THE GROVE
JZ24-31

JZ24-31 THE GROVE PRO PLAN WITH REZONING 18.745

Public hearing at the request of Ivanhoe Development for a Zoning Map Amendment from Office Service Technology to Low-Density Multiple Family with a Planned Rezoning Overlay. The subject site is approximately 62 acres and is located east of Meadowbrook Road, south of Twelve Mile Road (Section 13). The applicant is proposing to develop a 232-unit townhome development.

DATE 7/14/24	SCALE	HOR: 1" = 100' VER: 1" = N/A	
DESIGNED BY SRB	JOB NO.	22149	
DRAWN BY DAB	SHEET	SP-3.6

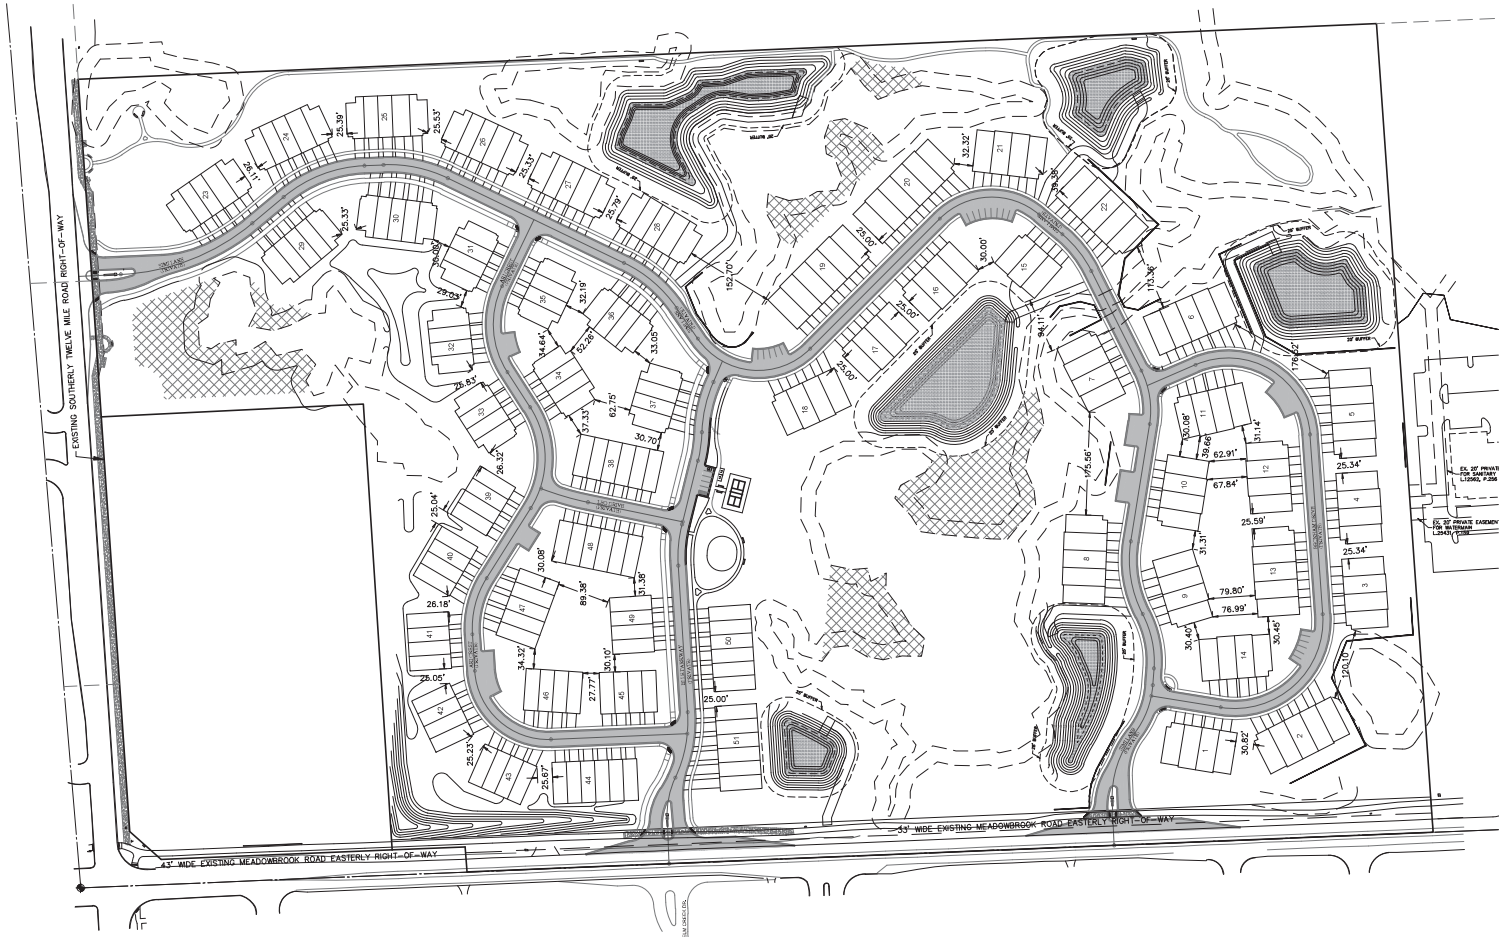
3. **Distance between Buildings** *(Sec 3.8.2.H):* A Zoning Ordinance deviation is requested to reduce the building separation distance from the calculated formula as shown on the Building Separation Table on Sheet SP-3.6 of the PRO Plan). *This deviation enables the layout of this project to fit within the available space while minimizing wetland and woodland impacts.*

3. **Distance between Buildings** *(Sec 3.8.2.H): A Zoning Ordinance deviation is requested to reduce the building separation distance from the calculated formula as shown on the Building Separation Table on Sheet SP-3.6 of the PRO Plan).* **This deviation enables the layout of this project to fit within the available space while minimizing wetland and woodland impacts.**
